CS Memorandum No. 1698

Subject: Configuration Management Board Meeting No. 169

CMB Meeting Minutes #169

SUBJECT: Configuration Management Board Meeting # 169 – Rev. No. 0

**BUILDING PROTECTION
COMPENSATION GROUTING
LAYOUT PLAN**

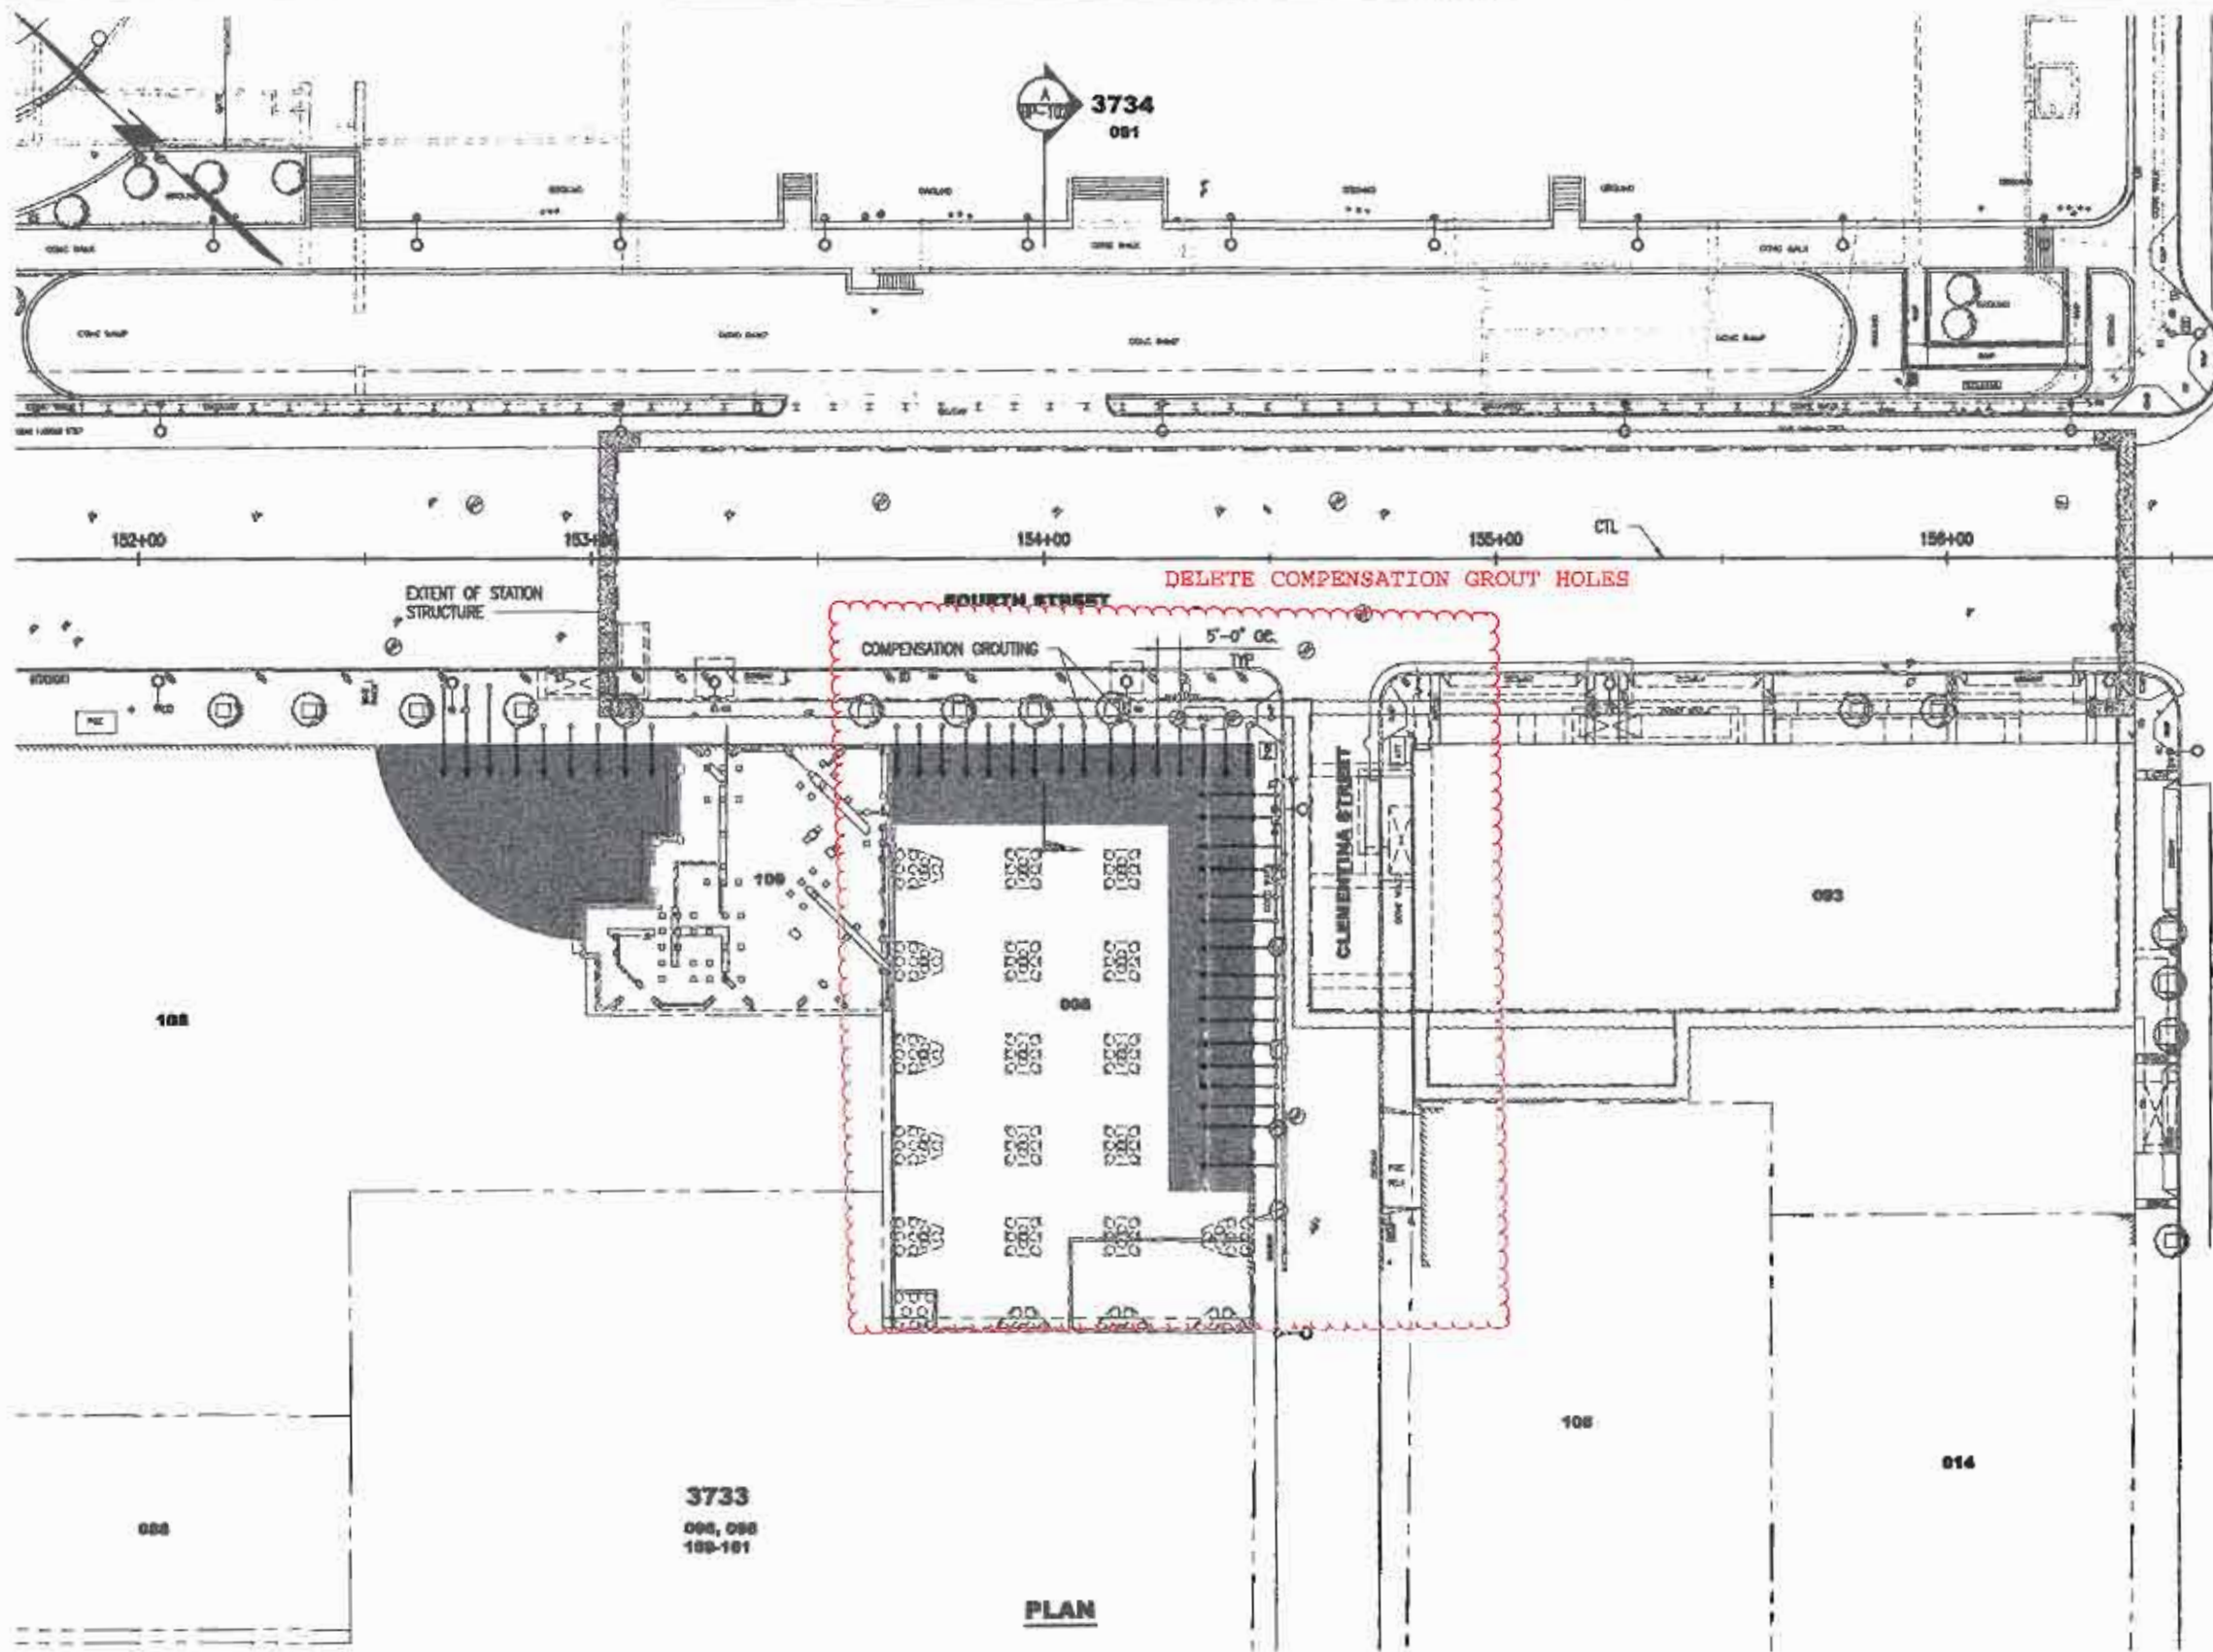
4-	R. Redmond presented for discussion Contract 1300 Contractor's letter outlining a VE proposal for the reduction of scope in compensation grouting work at YBM; along 4th and Clementina Streets. The Board took exception to this information stating the previous actions had discussed deletion of work and a credit from the Contractor for deletion of scope. The Board recommended a response letter denying the VE and requesting a proposed credit for scope deletion.

Layne is in receipt of your email dated February 25, 2014 requesting a credit proposal to reduce the compensation grouting work at the YBM Station from 41 to 9 holes as per the attached contract drawing. Layne is submitting this credit proposal as a Value Engineering in accordance with specifications Section 01 24 13.
